**RE: Comments of Renewable Northwest, Docket UE-200304**

Utilities and Transportation Commission's January 5, 2021, Notice of Opportunity to File Written Comments Relating to Puget Sound Energy's 2021 Draft Integrated Resource Plan for Electricity, Docket UE-200304.

Figure 8-12: Net Cost of Capacity in the Portfolio Model

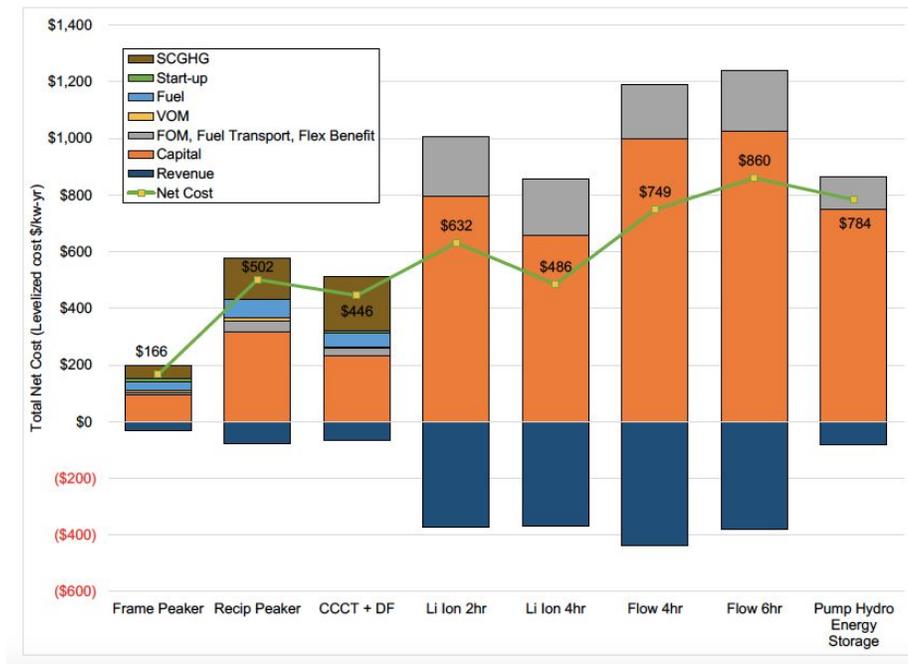
PSE provides a levelized cost of capacity comparison for peakers, baseload gas plants, and energy storage resources in the Mid Scenario, illustrated by *Figure 8-12* in the Draft IRP:

However, public data and other IRP filings support lower capital cost estimates (\$/kW) than PSE has incorporated in their modeling. For example, the National Renewable Energy Laboratory’s (“NREL”) 2018 Annual Technology Baseline (“ATB”) reports meaningfully lower costs for 2-hour and 4-hour lithium-ion batteries with mid-cost projections (shown in *Figure 1* below). The most recent cost estimates reflected in NREL’s 2020 ATB are lower still at \$1500/kW for a moderate-level projection (shown in *Figure 2* below). On the other hand, the 4-hour Li-ion battery capital cost assumed for the “Levelized Capacity Cost” (in PSE’s Figure 8-12 reproduced above) calculation would produce a range of \$2300-2400 kW/year, assuming a 15-year system lifecycle and a capacity credit of 25% -- a very conservative estimate. Battery storage costs are falling rapidly and efficiencies are increasing due to technological advancements and economies of scale. Battery storage systems are increasingly emerging as important assets for the future grid -- and even the present grid -- to integrate increasing penetrations of non-emitting resources. Thus, evaluating their cost and operating parameters appropriately in the current IRP cycle would not only meet the company’s obligations this IRP cycle but also lay important groundwork for future resource planning.
